Re: St. Lucie Unit 2
Docket No. 50-389
Order (EA-03-009) Interim RPVH Inspection Requirements
Revised Relaxation Requests 1 and 2 - Supplement 4

ST. LUCIE UNIT 2 RELAXATION REQUEST NO. 1 REVISION 2 FROM US NRC ORDER EA-03-009

ST. LUCIE UNIT 2 RELAXATION REQUEST NO. 2 REVISION 1 FROM US NRC ORDER EA-03-009

Figure 1
Typical St. Lucie Unit 2 CEDM Nozzle Configuration

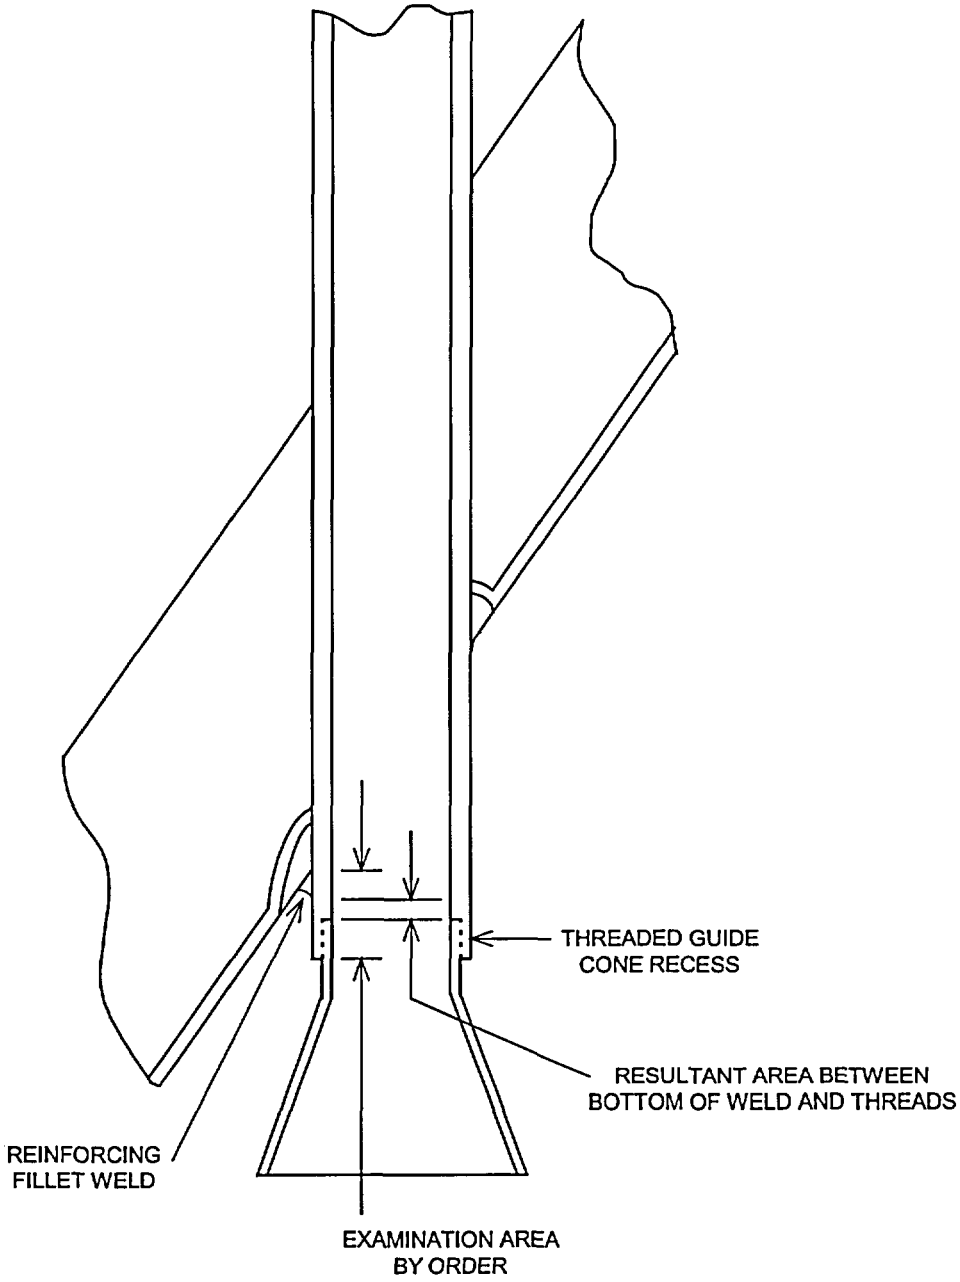
The configuration described above does not allow for inspection of a minimum of 1 inch below the weld, as proposed in Revision 0 of Relaxation Request 1.[3,4] A typical example of the internally threaded nozzle, including the externally threaded guide funnel, at a high hillside angle is shown in Figure 1.

Figure 2: Graphical Determination of Minimum Inspection Coverage Distance Below the Weld to Support an Additional 18-Month Operation Period, and Additional Margin at a UT Inspection Coverage Distance of 0.41 Inches (exploded section from Figure 6-16 of WCAP-16038-P).

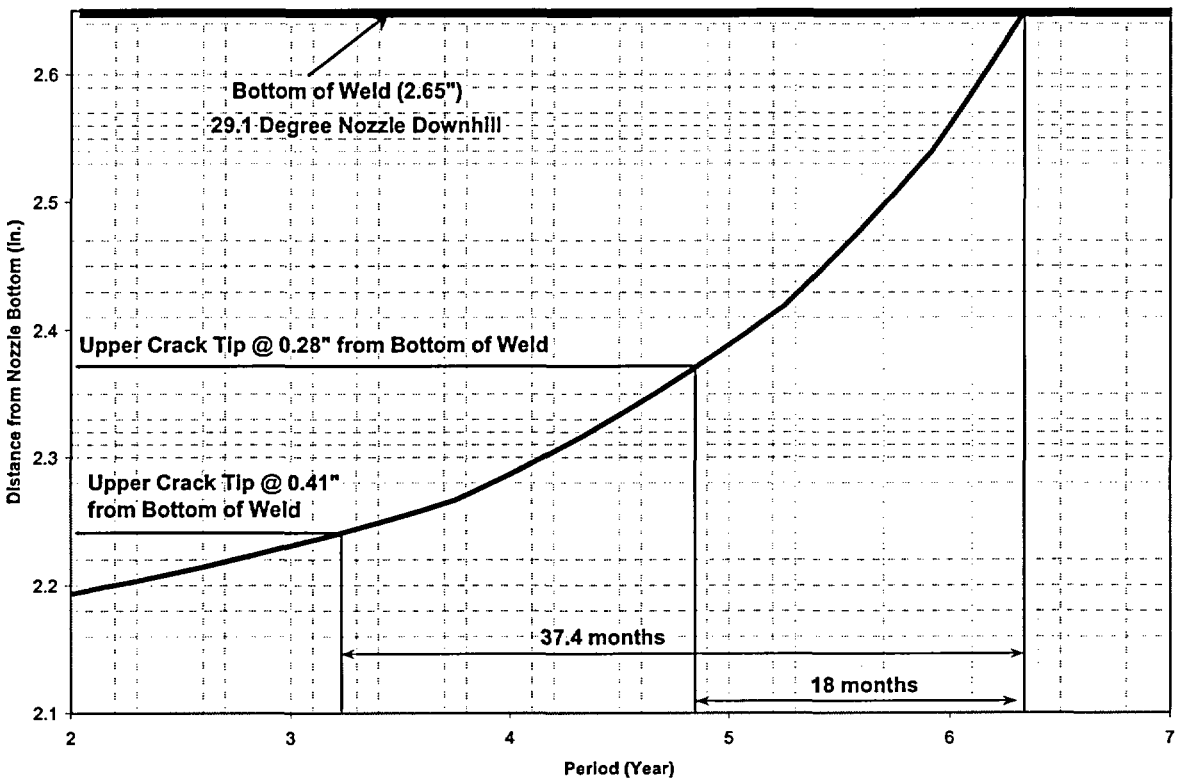
Figure 2 provides a check of the determination in Table 1, using the 29.1° nozzle example.

Figure 3: Typical UT "C" Scan of Nozzle 43 Showing Minimum and Maximum Coverage Area Below the Weld

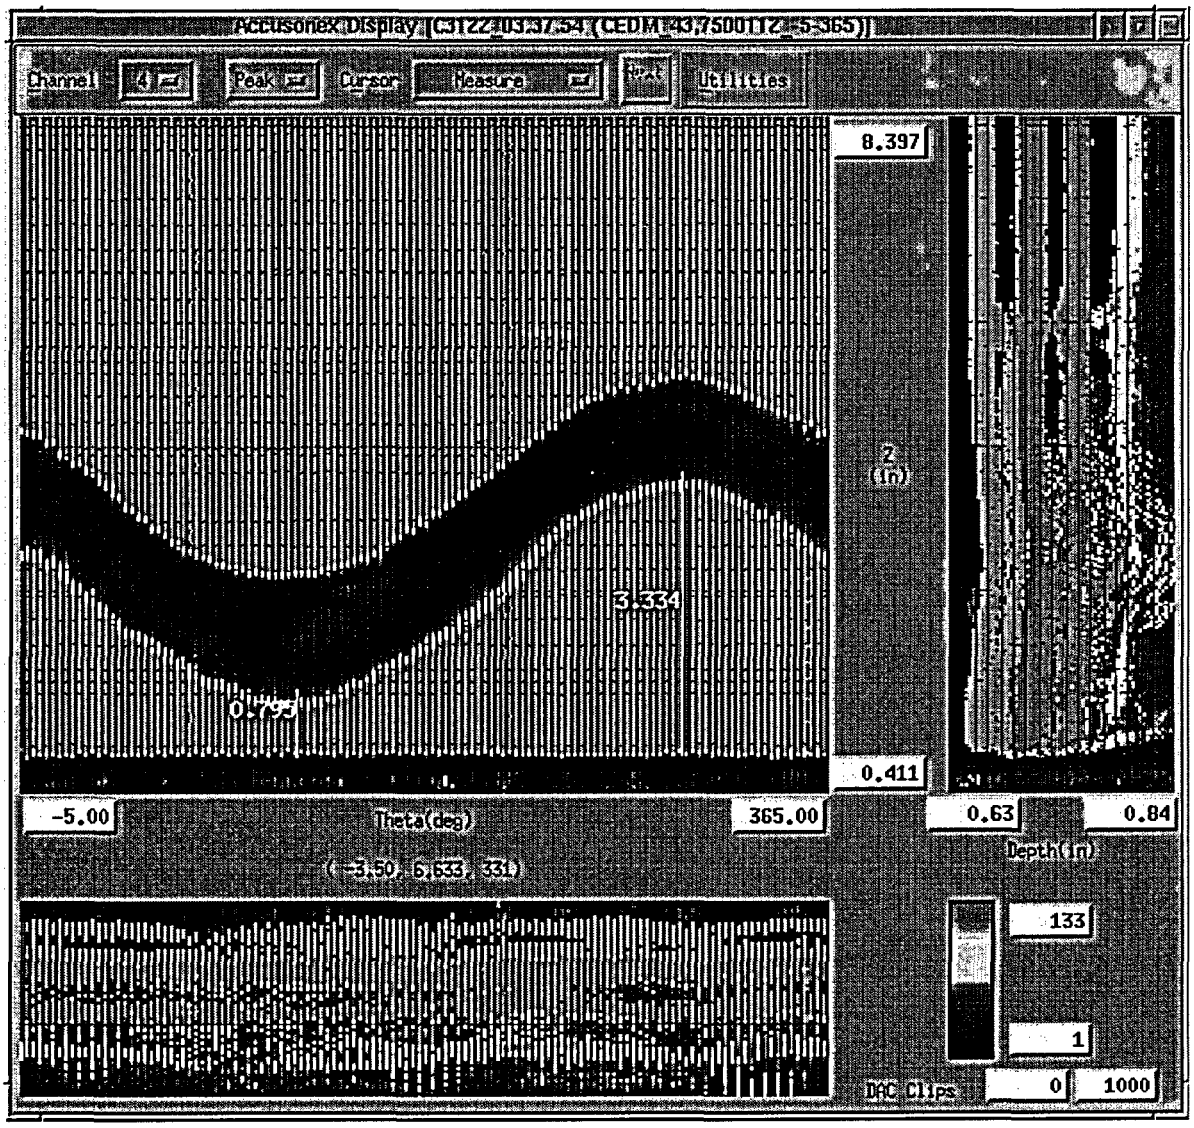
The UT coverage for a typical CEDM nozzle is shown in Figure 3. Since all of the 91 CEDM penetrations are unobstructed on the ID, 100% scan coverage can be obtained above the threaded area. This includes 100% of the area adjacent to the interference fit region between the nozzle and the head, for assessment of a potential "leak path." In the example below, the extent of UT coverage below the weld ranges from 0.79 inches at the downhill side to a maximum of 3.33 inches on the uphill side.

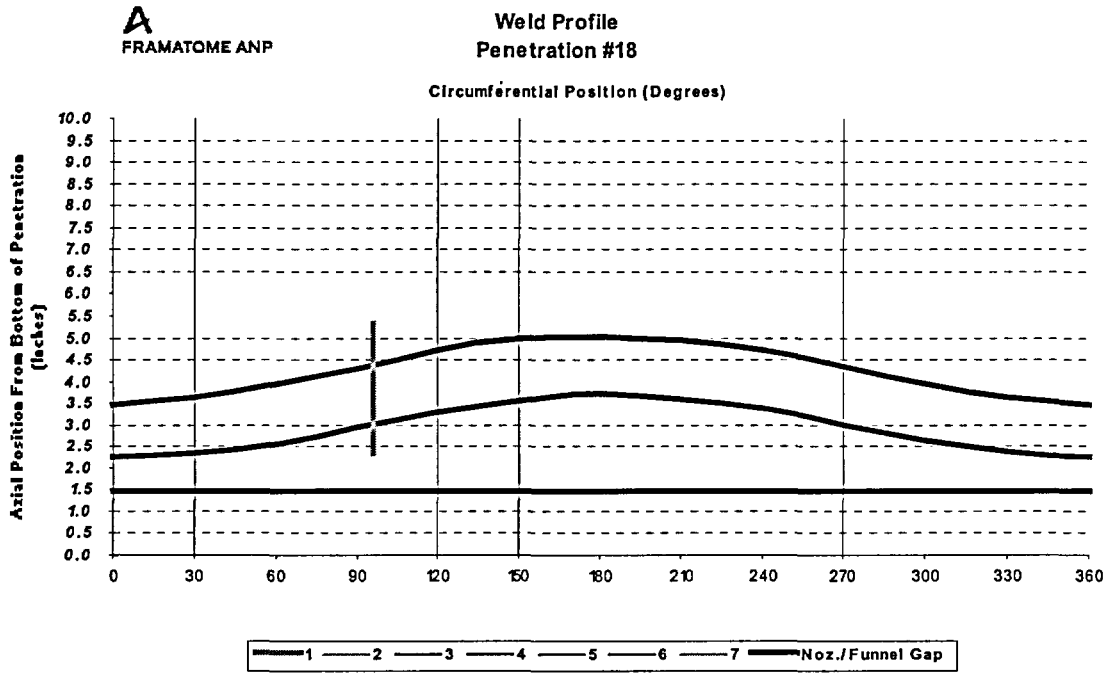
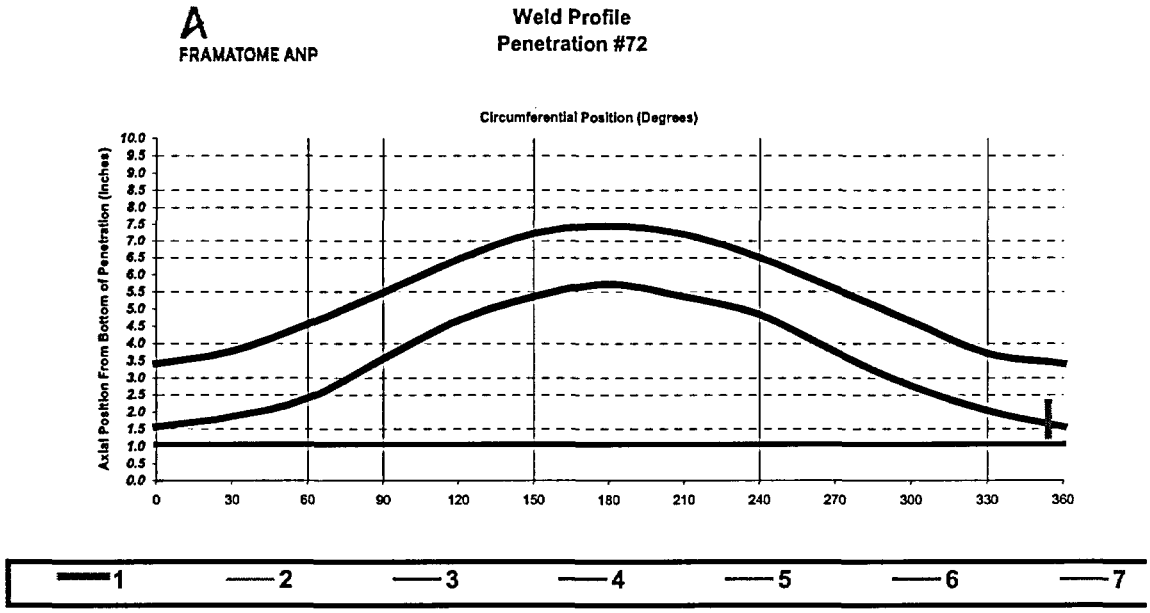
NRC Question 3: Provide the location of the flaw for Penetration Nos.18 and 72 relative to the weld and azimuthal angle around the nozzle.

FPL Response to Question 3: A single flaw was identified in Nozzle Nos. 18 and 72 at St. Lucie Unit 2. The details of each are provided in the table below. A graphical weld profile and flaw orientation is also provided. The 0° is identified as lowest downhill position of the weld.

Nozzle #	Flaw Location /Type	Azimuthal Location	Flaw Length	Flaw Depth	Distance Below Weld
18	OD Axial	96°	2.98"	0.26"	0.71"
72	OD Axial	354°	0.96"	0.28"	0.35"

Figure 1: Picture Showing Shroud Support Lug and Flashing Location

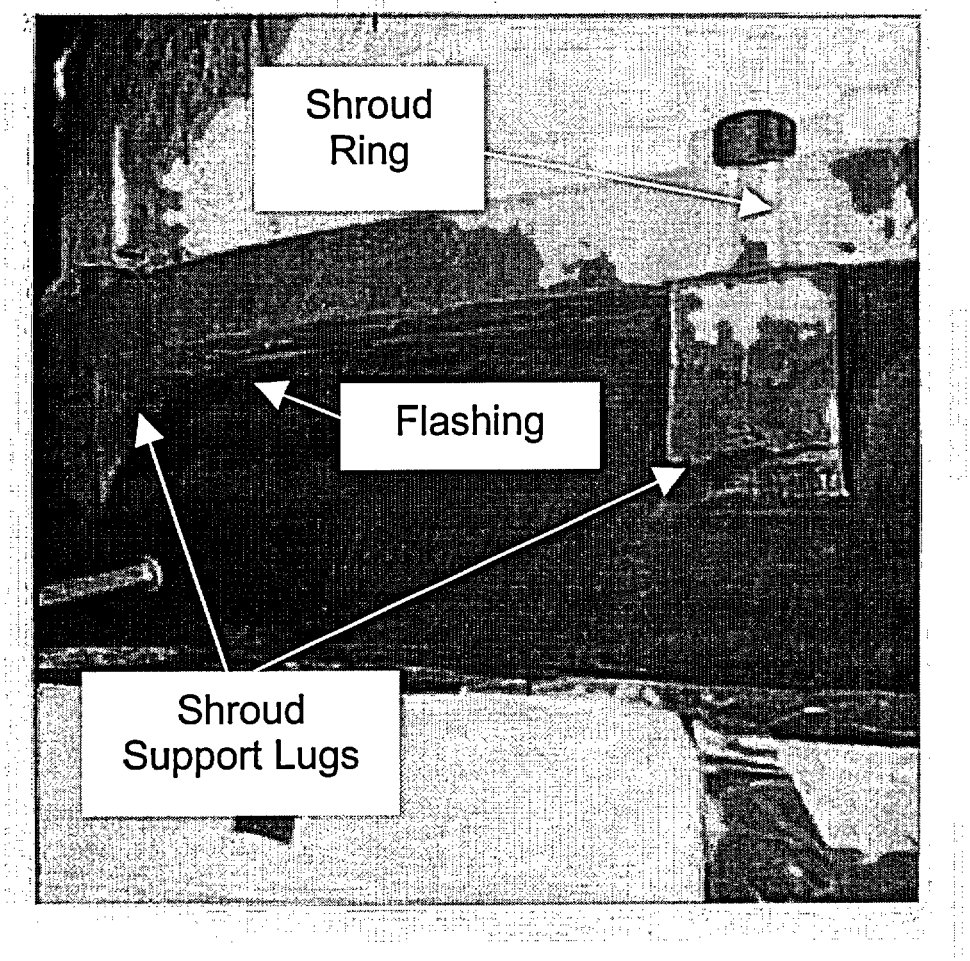
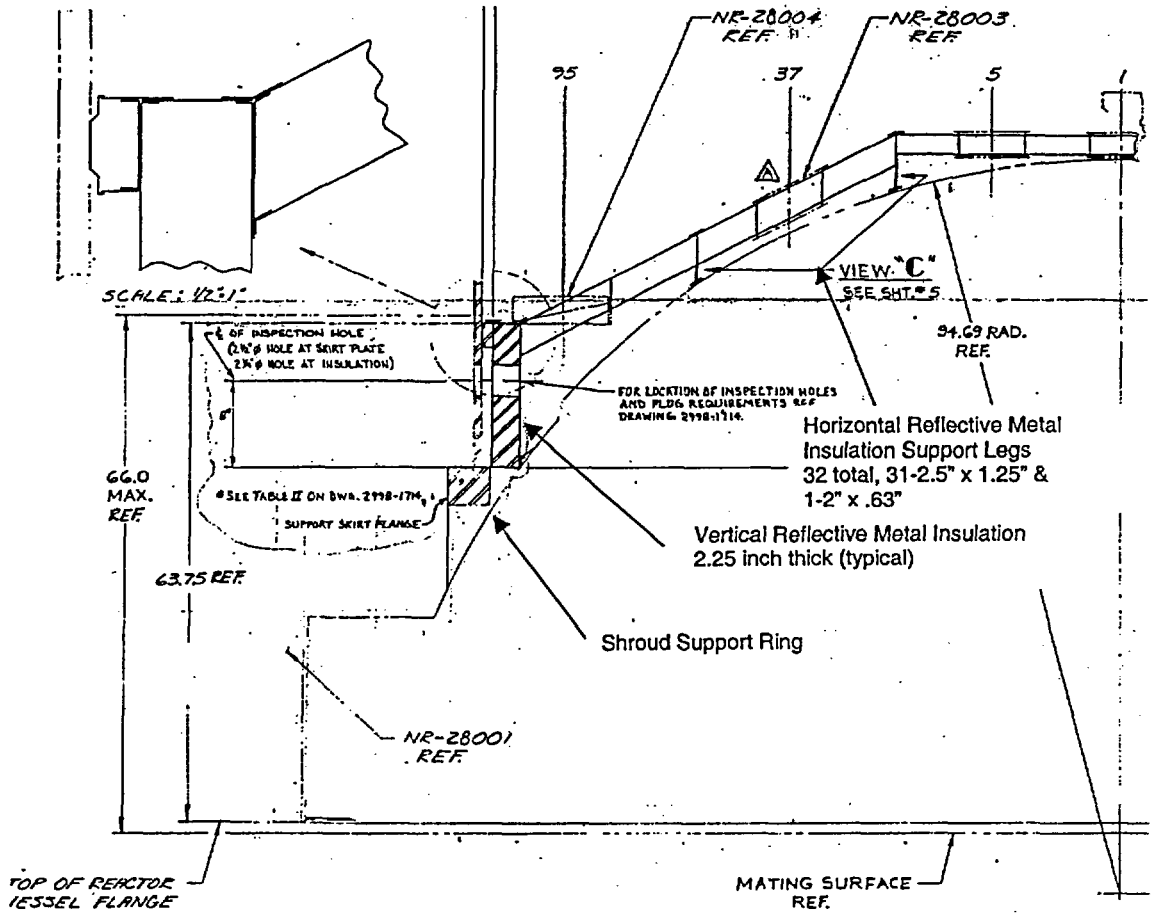
Relaxation is requested from part IV.C.(1)(a) of the Order to perform "bare metal visual examination of 100% of the RPV head surface (including 360° around each RPV head penetration nozzle)" at St. Lucie Unit 2. Specifically, FPL is unable to completely comply with this requirement due to inaccessibility to a small portion of the RPV head surface. The inaccessible areas are behind the twelve 6-inch wide shroud lugs and under the horizontal reflective metal insulation (RMI) support legs.

FPL has achieved substantial compliance with the 100% requirement by conducting a bare metal visual examination of the RPV head surface to the extent practical, excluding the inside of the 54 RPV stud holes. Specifically, the examination included a visual examination of 100% of the nozzle-to-top-of-head interface region (360°) of each RPV head penetration nozzle for evidence of leakage and an examination of the bare head surface for evidence of wastage or corrosive products.

Figure 3: Picture Showing Horizontal RMI Support Leg

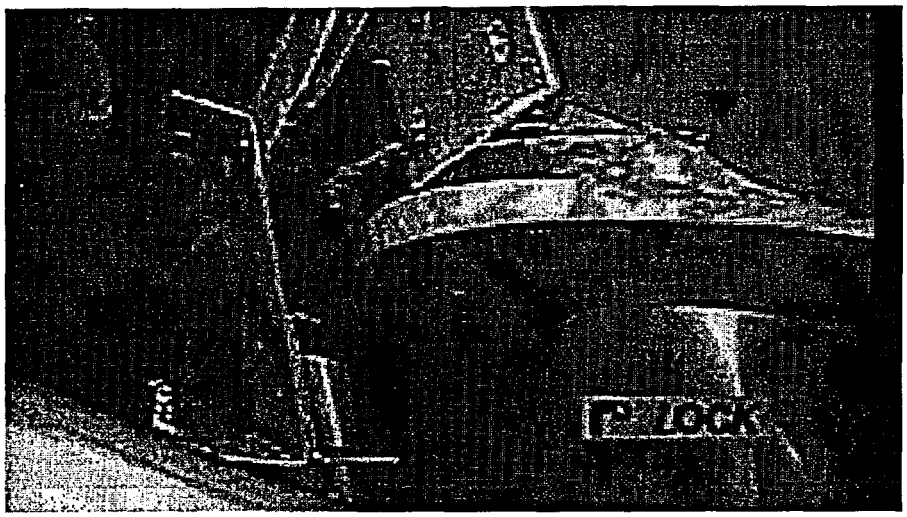
Figure 3, many of the horizontal BMI support legs were tilted allowing additional visual access to the RPV head base material. The ability to remove the flashing panel beneath the shroud ring, and slightly lift the vertical RMI panels, resulted in inspection of approximately 99% of the RPV head. This percentage does not take credit for the additional coverage obtained by the tilted support legs.
